MP10_160 Mod 6 White Rock Wind Farm (WRWF) - Further Information

This letter has been prepared by White Rock Wind Farm Pty Ltd (WRWFPL) in response to the Department's request for further information (RFI, email dated 21 November 2018), to address additional comments received from the Office of Environment and Heritage (OEH) and the Roads and Maritime Service (RMS).

1. OEH Request for Further Information (Letter dated 5 November 2018)

2. RMS Request for Further Information (Email dated 8 November 2018)

0 150 300 600 Metres

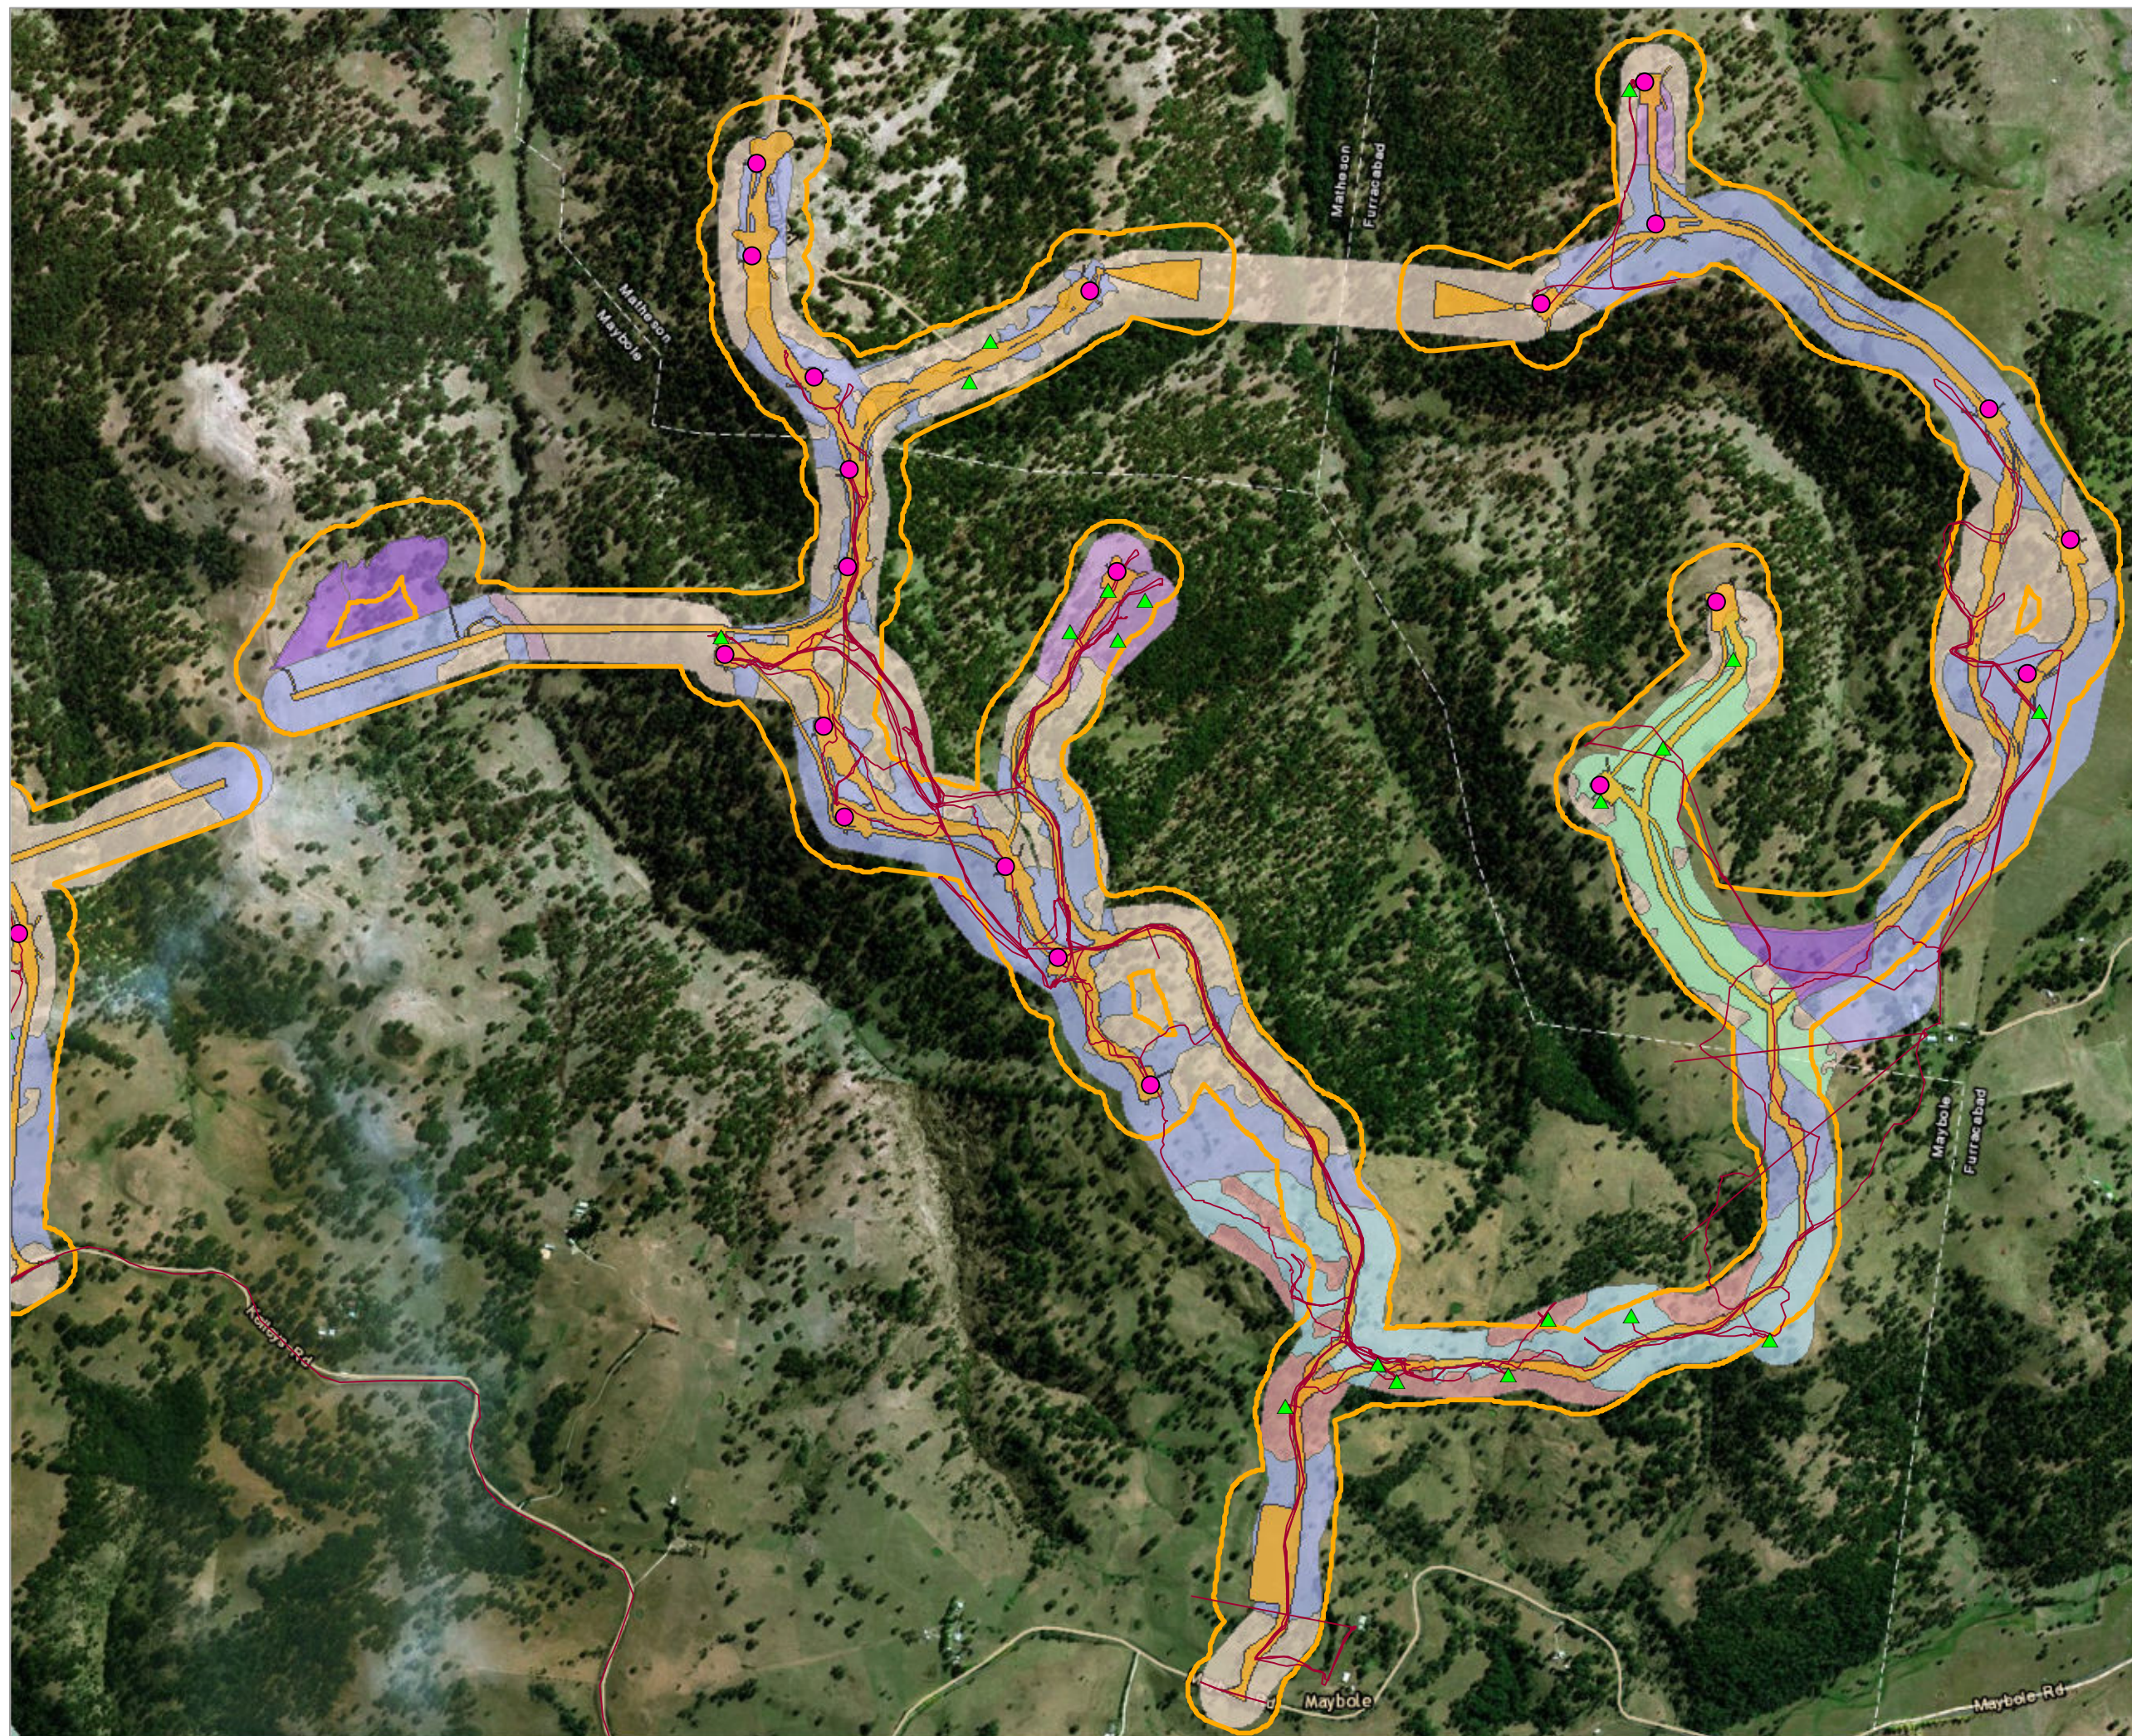
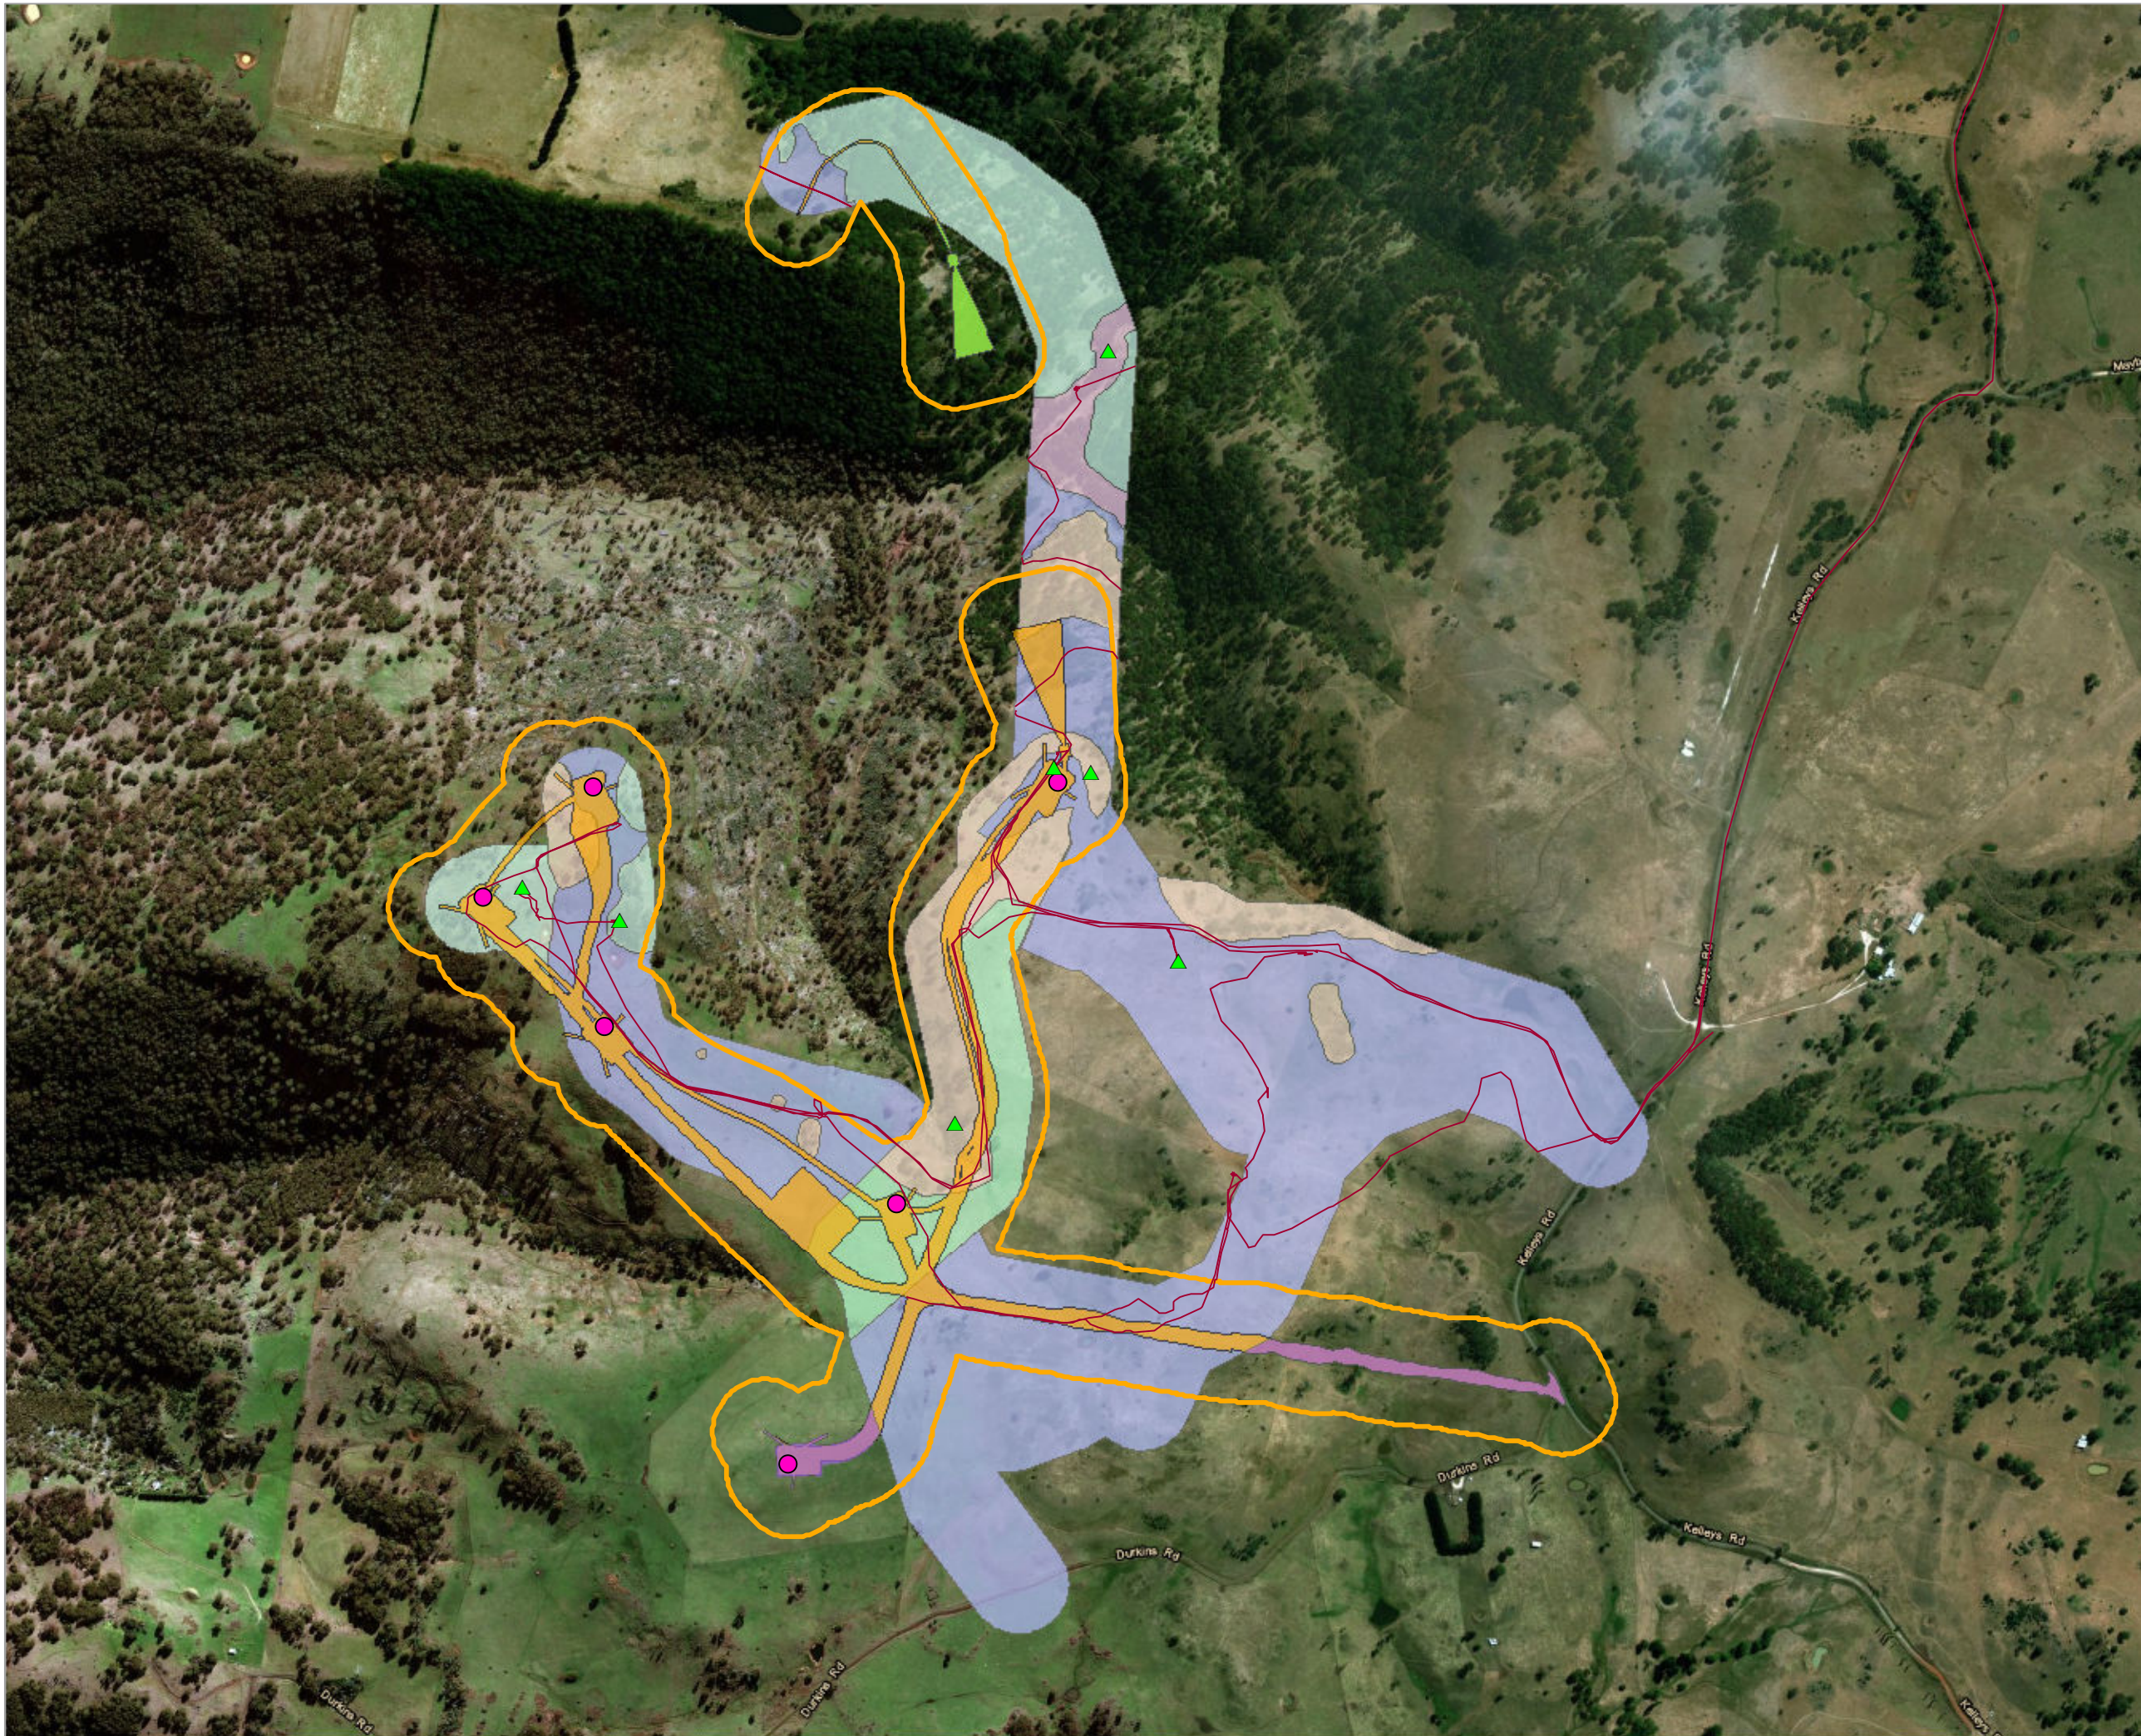
5	Inconsistent reflection of flora sampling methodology Figure 4-1 within the BAR appears to be inconsistent with the sampling description provided in text and the requirements of the 'NSW Guide to Surveying Threatened Plants'.	Figure 4-1 of the BAR shows the location of threatened flora surveys, however as detailed in Section 4.5.2, three people were involved in each of the threatened species surveys, meaning that a width of 30 m per transect was covered in each of the mapped transect. Maps of our GPS tracks, marking the central transect, are provided with this letter (Attachment 2). Note that a number of survey tracks are not able to be mapped. As discussed above, these surveys were undertaken within areas determined as a higher likelihood of occurrence for the target species, based on habitat quality, within the access track easements and wind turbine pad footprints. These surveys combined with the analysis of records within the broader locality are considered adequate to have detected the presence of threatened flora species within the development envelope.				NGH Environmental proposed way forward: Ask OEH to reconsider adequacy with reference to Table 2's justification of any deviations from FBA.

However, Figure 4-1 contained within the BAR illustrates targeted flora survey tracks which do not appear to reflect the methodology outlined above, and which appears to be inconsistent with the sampling description provided in text and the requirements of the '*NSW Guide to Surveying Threatened Plants*'.

0.0 Km's: Mayfield #4 onto Selwyn Street at Mayfield.

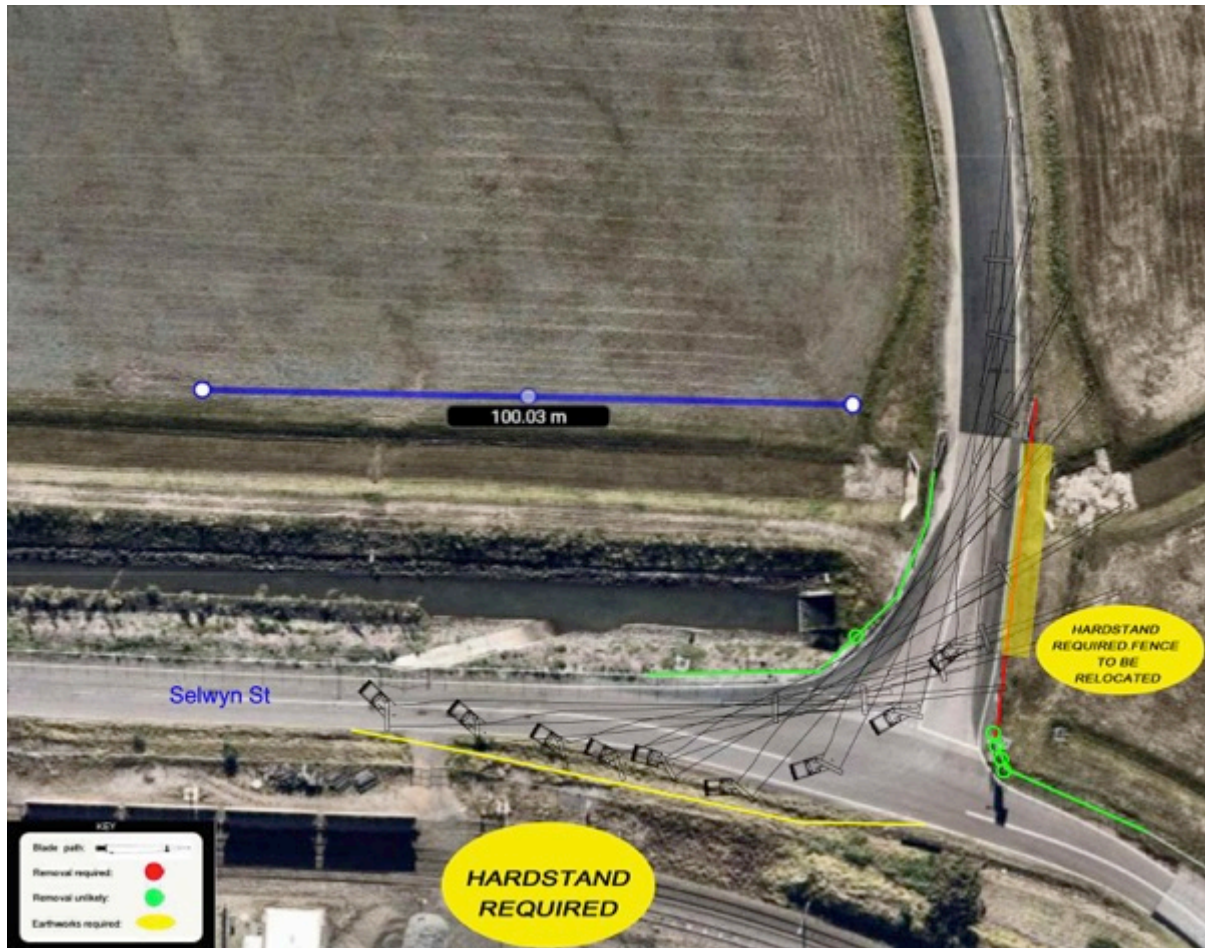
COMMENTS: Some hardstand will need to be added to the left entry and exit of the corner. Some signs will need to be relocated and or made removable and some fence will need to be relocated.

ROAD MODIFICATIONS: Yes moderate amounts of work are required.

1.3 Km's: Selwyn Street onto Industrial Drive, via George Street at Mayfield.

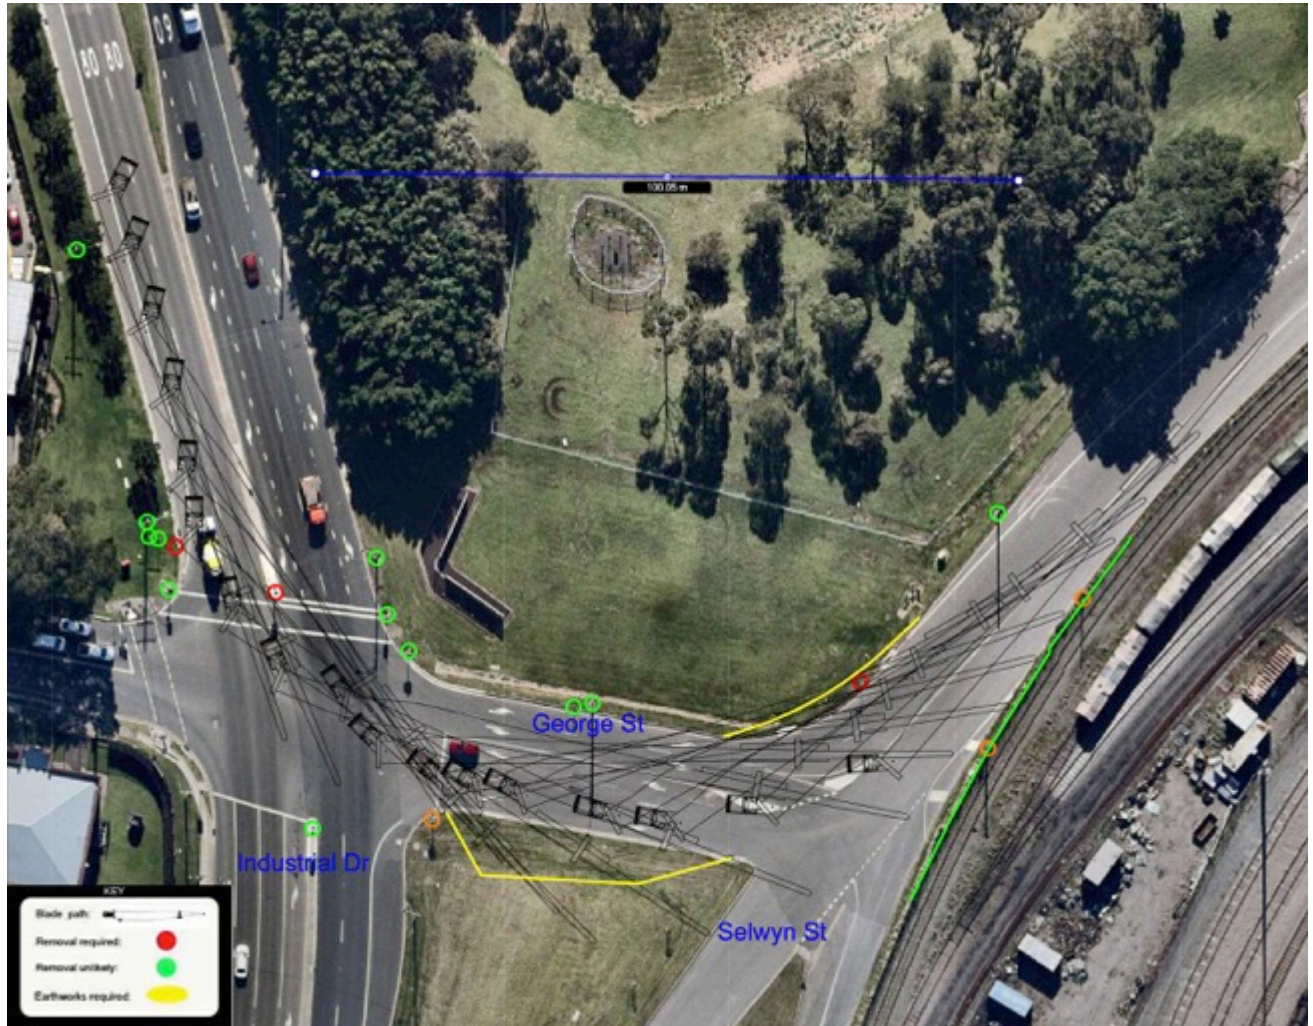
COMMENTS: The first right hand turn through George Street will need a sign made removable. Entering Industrial Drive the loads will cross from the correct side to the correct side. The traffic signal in the centre median will need to be relocated. Some hardstand will need to be placed on the south side of the intersection.

ROAD MODIFICATIONS: Yes, large amounts of works are required.
